Report to Development Permit Panel

DP 06-352741

Application by Polygon Meridian Gate Homes Ltd. for a Development Permit at

9200, 9240, 9280, 9300 and 9320 Odlin Road

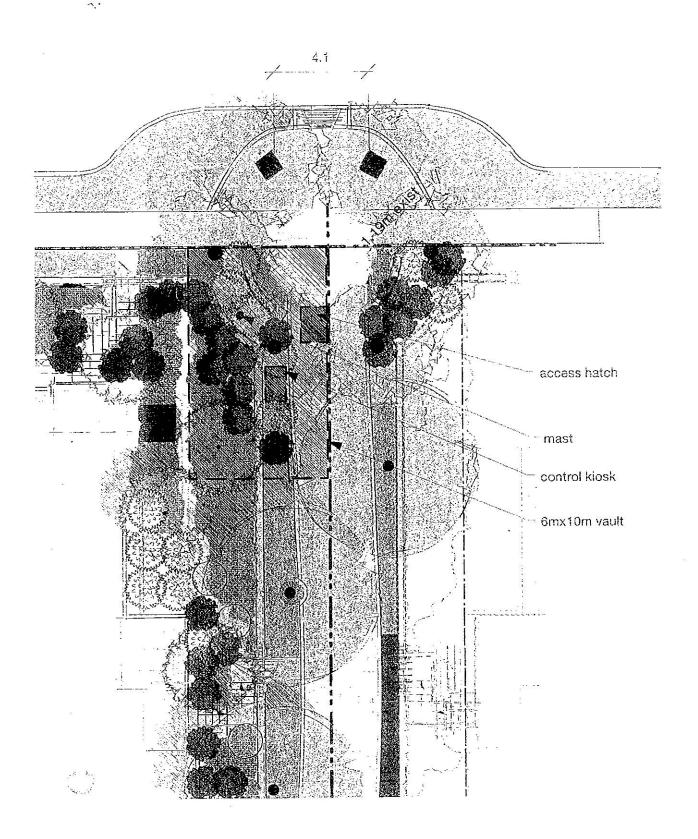
· consider improving and minimizing the large roof:

Our reduced decks have created opportunities for additional breaks in the eaves, but these are hard to achieve without making the roof excessively complicated. We are having another look to take whatever opportunities we can, but there are limits to how much change we can realistically expect. All of the roofs were smaller at the second ADP than they were at the first and we have created quite a bit of articulation with projecting bays etc.

Section: Alexandra Way Scale: 1:50

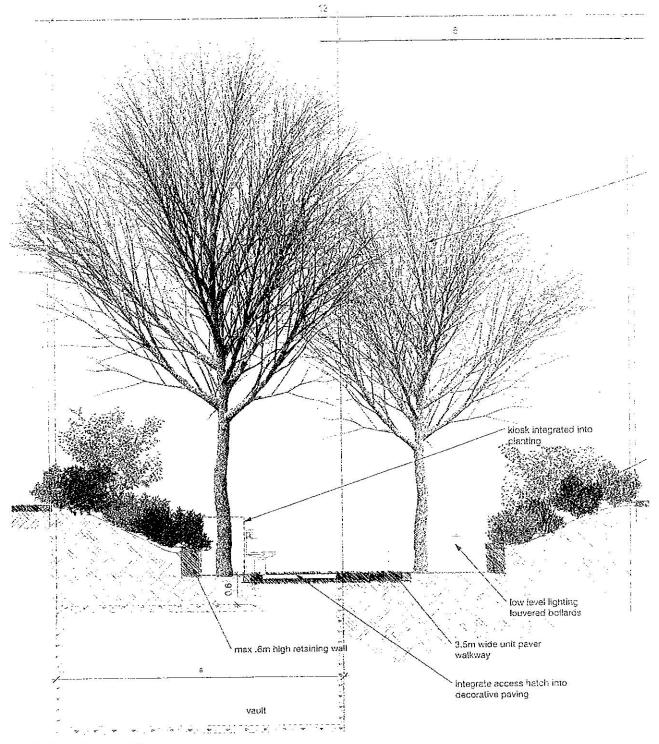
create a wider pathway along Alexandra Way:

Widening the pathway from 2.5m to 3m will reduce planting, but is acceptable. Additional landscaping would need to be installed at a later date by the neighbouring developer when the temporary path is taken out. Anything greater than 3m in width becomes too wide and will take up almost all of the greenway (negating the green aspect).
